**DELTA CONVEYANCE DESIGN AND CONSTRUCTION AUTHORITY STAKEHOLDER ENGAGEMENT COMMITTEE**

REGULAR MEETING AGENDA

Wednesday, April 22, 2020

# Key SEC Siting Comments from March 11th Meeting

# Intakes Traffic Routes – Stone Lakes Refuge Considerations

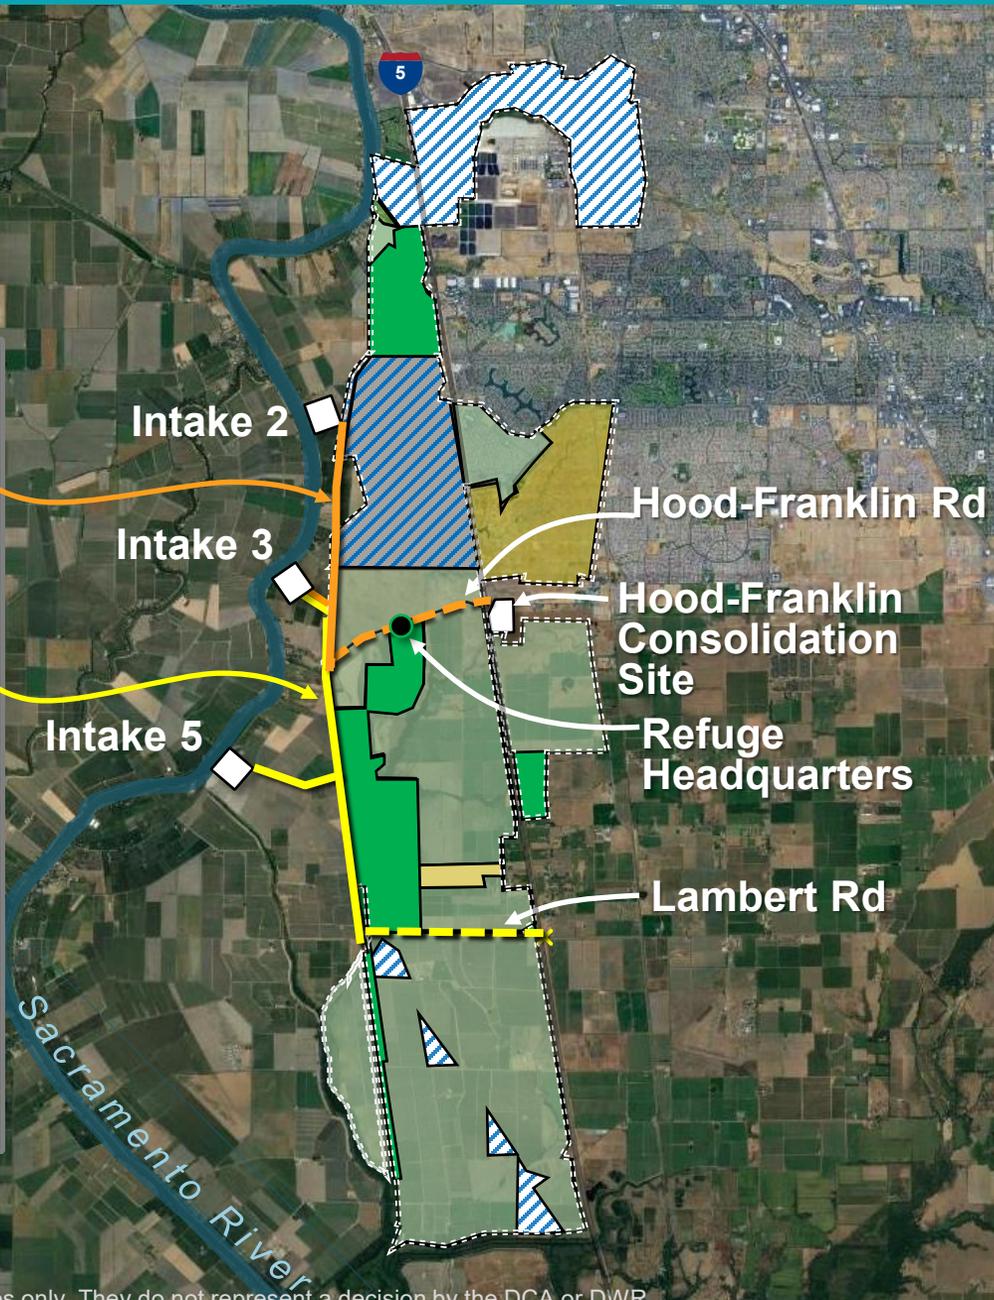
Mr. Wirth asked to discuss the slide with Intakes 2 and 3 in the area near Stone Lakes Wildlife Refuge, which is one of the most threatened wildlife refuges in the country. Part of it is constrained by urban development to the east and north. Putting in the haul roads as currently configured would add impacts to the west and south, further threatening the area for sensitive species. On the Staten Island Maintenance Shaft map, a maintenance shaft is depicted in a pinch point to the east of Staten Island Road. That area has been a very successful roost site for the Greater Sandhill Crane over a great number of years. Sandhill Cranes require very long sight lines in order to consider using a roost site. It would be much better to find a spot for the maintenance shaft where the island is a lot wider. Keeping it in the place it is shown on the map would mean it is no longer available for a roost site. A lot of the cranes use Tyler Island because it is a very good placement for a roosting pond. Ms. Mallon asked Mr. Wirth where on the map would be a great spot for the maintenance shaft. Placement of maintenance shafts is pretty flexible. Mr. Wirth said it would be better if it were placed further south because the island is wider further south, but then it would not be on the tunnel as depicted in the map. Ms. Mallon

Osha Meserve, Friends of Stone Lake National Wildlife Refuge Association, said she has made some comments before but wanted to comment again about how the maps are coming together. Stone Lake National Wildlife Refuge has a boundary that is designated by Congress. It includes the entire area. On the maps shown, only the lands that have been purchased by the public is included or are under easement. It does not appear to be mapped properly. The entire boundary of the refuge must be included and anything through that area must be

**Intake 2 & 3  
Alternative:  
Hood-Franklin Road**

**Intake 3 & 5  
Alternative:  
Lambert Road**

# Bridges Potentially Impacted by Barge Routes

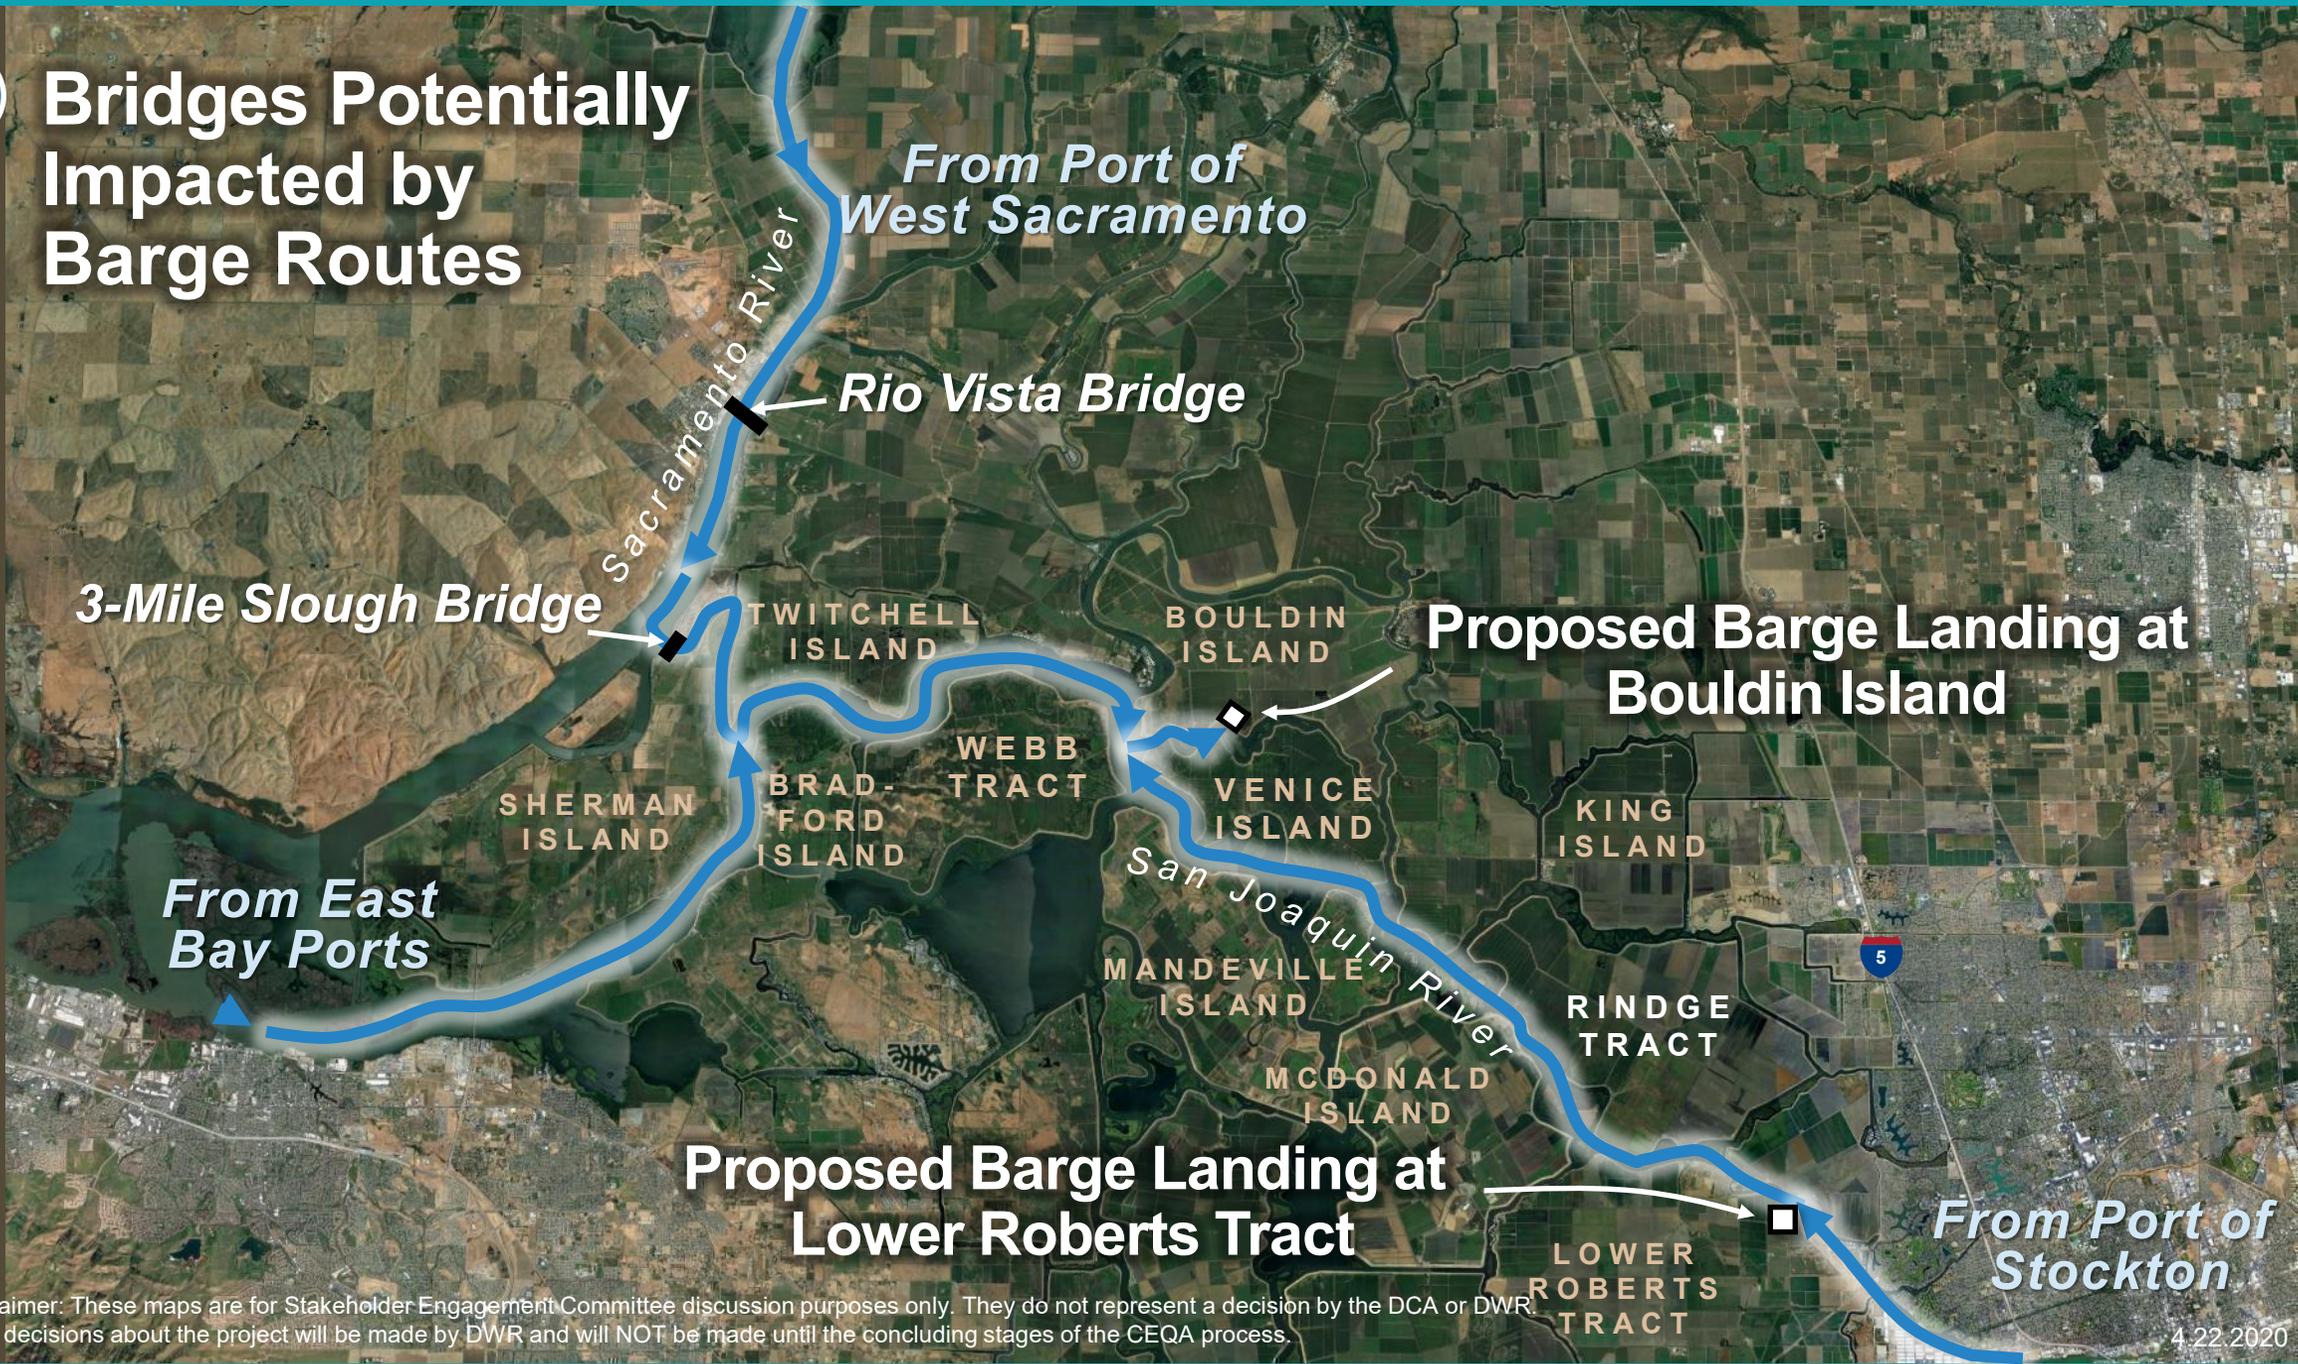
Mr. Hsia said when barges move through Walnut Grove, the bridges have to open up, which holds up traffic on the local roads. Barges are very disruptive. Mr. Ryan said the logistics routes have been planned carefully concerning barges and have intentionally avoided barge routes that cross bridges. Right now, there are only two areas where barging is being considered.

Former Shaft Location

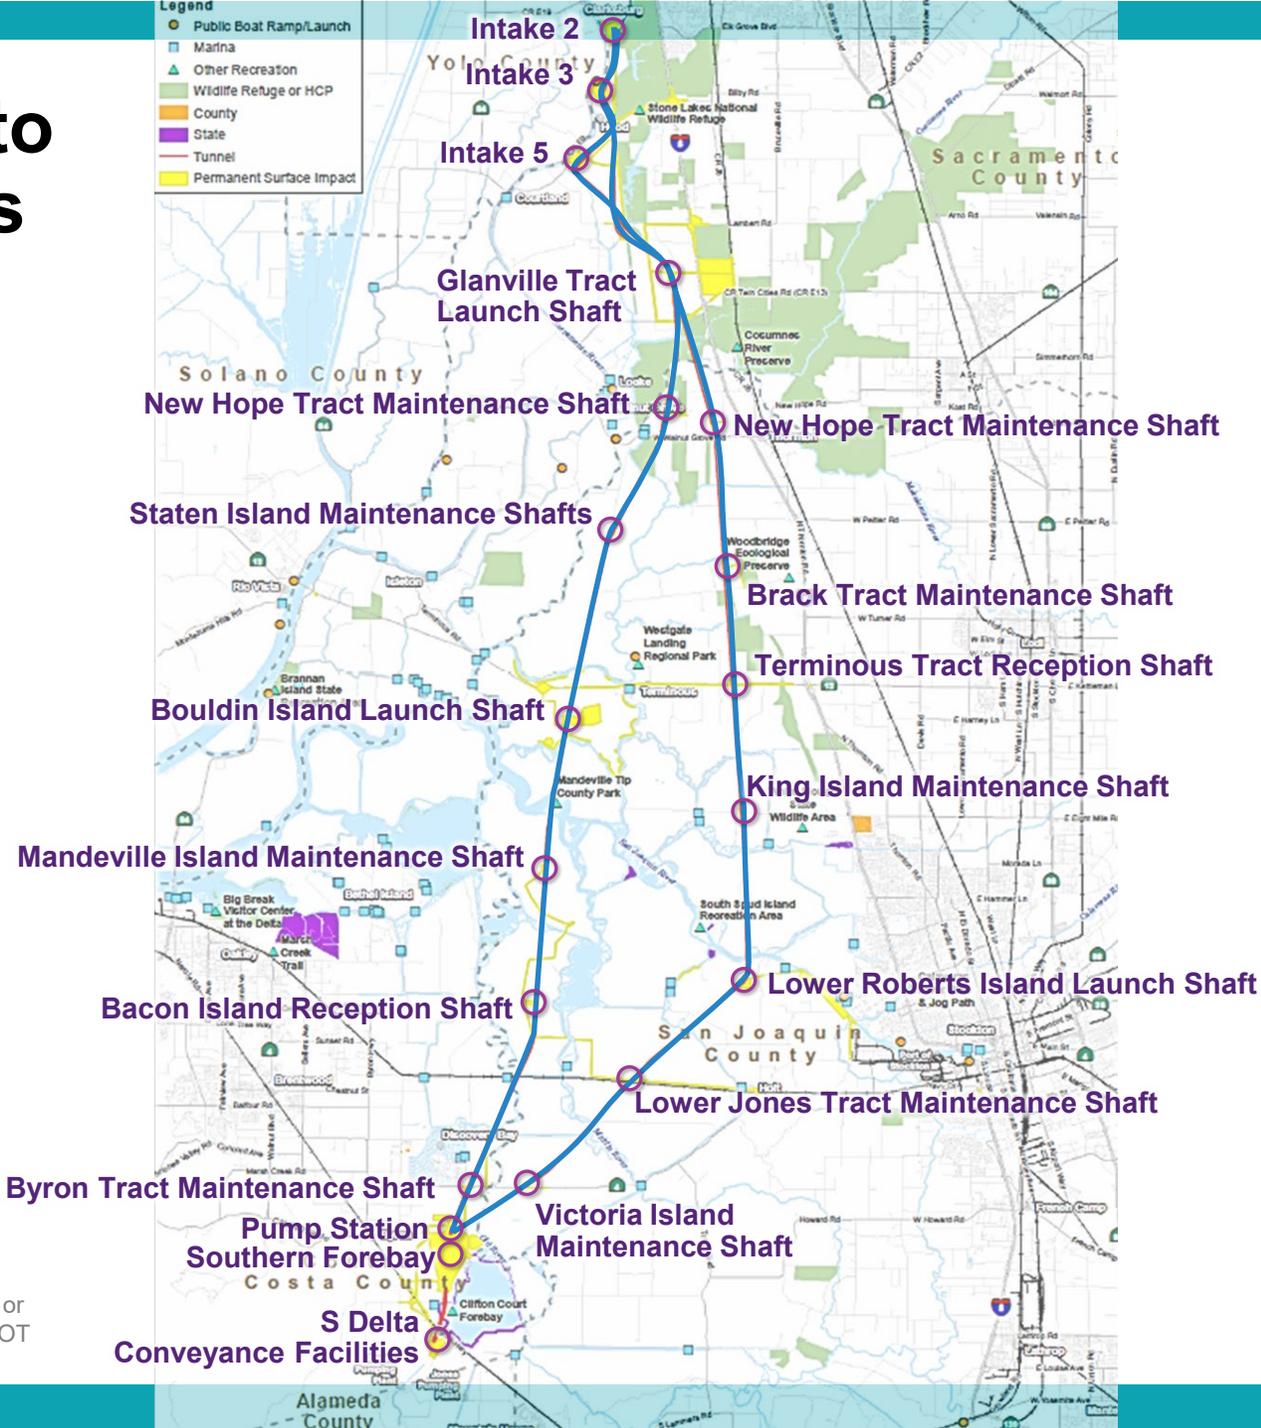
Mr. Hsia asked why West Walnut Grove Road would need to be extended from the railroad to Mokelumne River. Mr. Ryan said the road would be extended because it would provide access to the next shaft, which is on Staten Island and will be discussed momentarily.
